CITY OF BELLAIRE TEXAS

PLANNING AND ZONING COMMISSION

OCTOBER 11, 2018

- i. **Presentation by ChaVonne Sampson on the amendments made to the City's Comprehensive Plan and Code of Ordinances with regard to the property at 4800 Fournace Place.**

Exhibit A2. Proposed Site Layout and Access

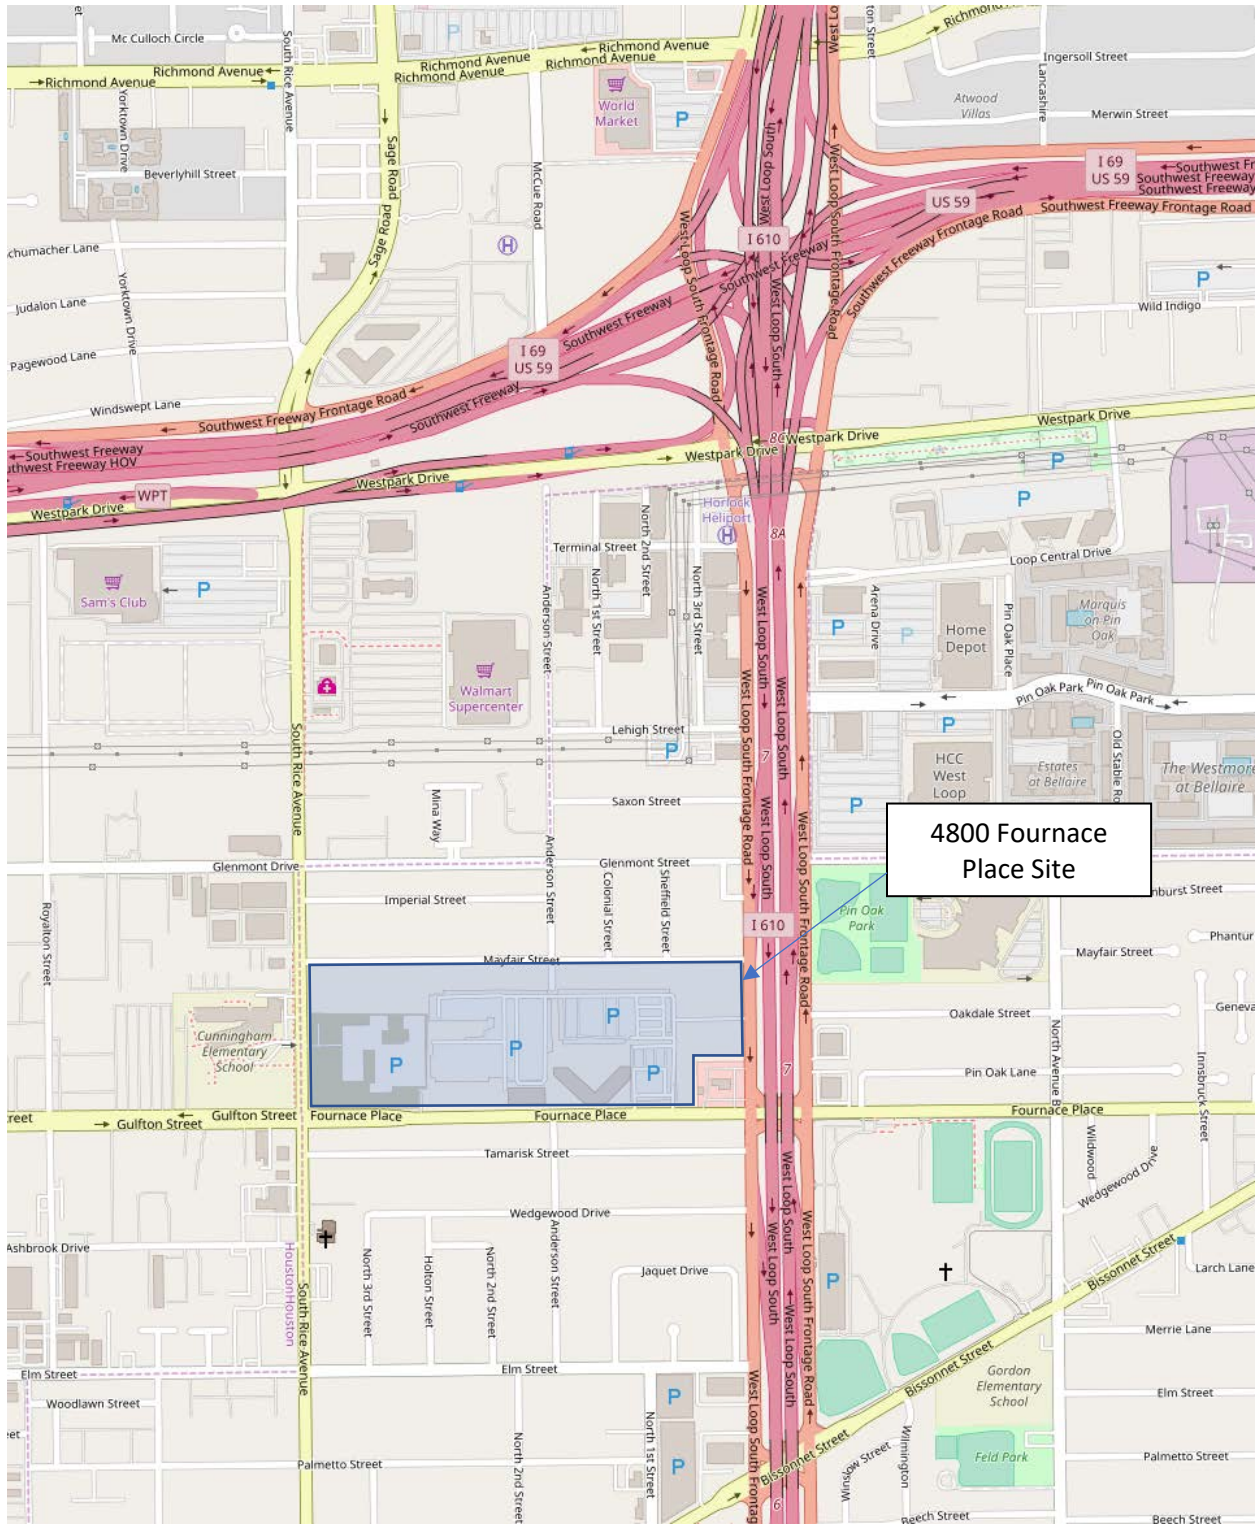
The revised site plan no longer proposes to move the site driveway on the IH-610 southbound frontage road (see Exhibit A2). As the land use will be consistent with what has been on this tract for many years, TxDOT approval for the garage construction should not be required. However, the property owner has been advised that any additional future development on the overall tract would be subject to TxDOT review of the impacts of the development and that the frontage road driveway may require modification or mitigation. Mr. Wright and I spoke on the phone about this comment and agreed to defer TxDOT approval until the point where a land use change is proposed, but the developer is now aware of this future requirement.
